As a City of Berkeley neighbor and a UC employee (working at University Hall), I can support the Acheson Commons development, with some very important caveats.

**Subject:** FW: 2133 University Ave - ZAB Packet

**Subject:** Acheson Commons Questions

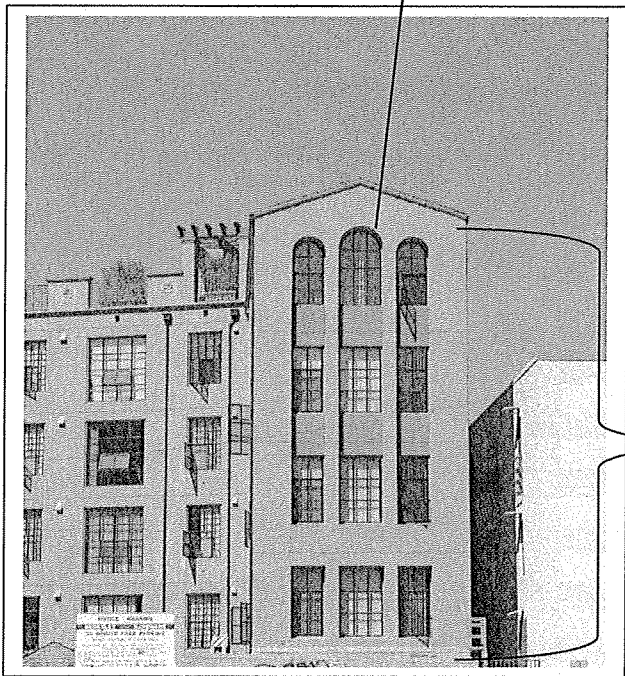
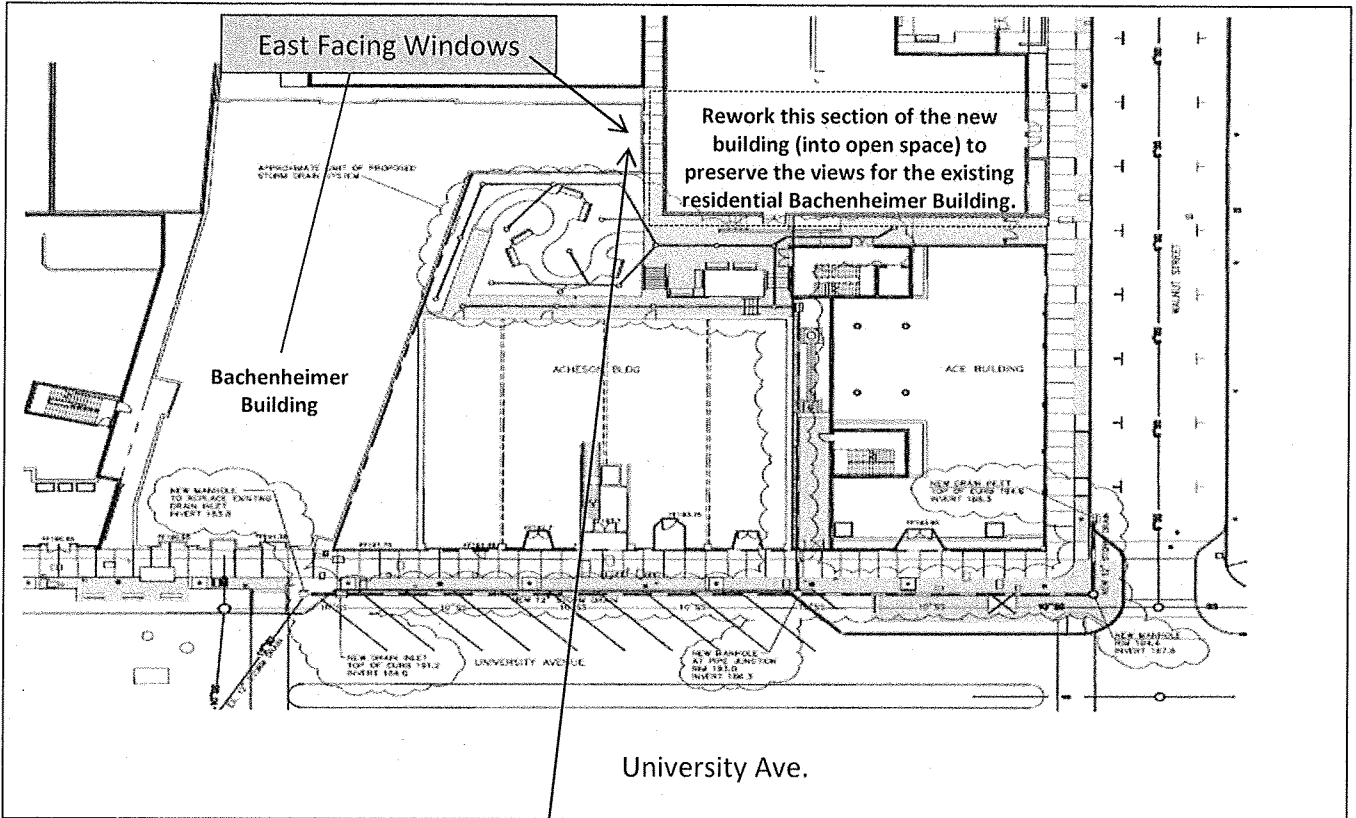
Secondly, as the project is currently proposed (when looking at the new buildings on the east side, on Walnut St.), they are situated too close to the eastern wing of the existing Bachenheimer Building. This end of the Bachenheimer Building has beautiful, large windows that now look out to views of the Berkeley Hills. If the new buildings are built as suggested, these large windows will have a view of their new neighbors less 20 feet away. In the developer's letter "response to the items deemed incomplete", submitted on 3/22/11, (on page 7 of the PDF), they state, "More open space could be provided on site, there are ample opportunities for the additional space." I think the project's open spaces should be planned around keeping the view-shed of these windows for the residents of their existing project and not ruin the living experience that these wonderful windows provide. The developer could reconfigure some of their planned "open space" to keep this end of the Bachenheimer Building from being completely hemmed-in. If need be, let them go up another story in part of the project.

Under the proposed plan, all four sets of these windows will look into their neighbor's unit, less than 20 feet away.
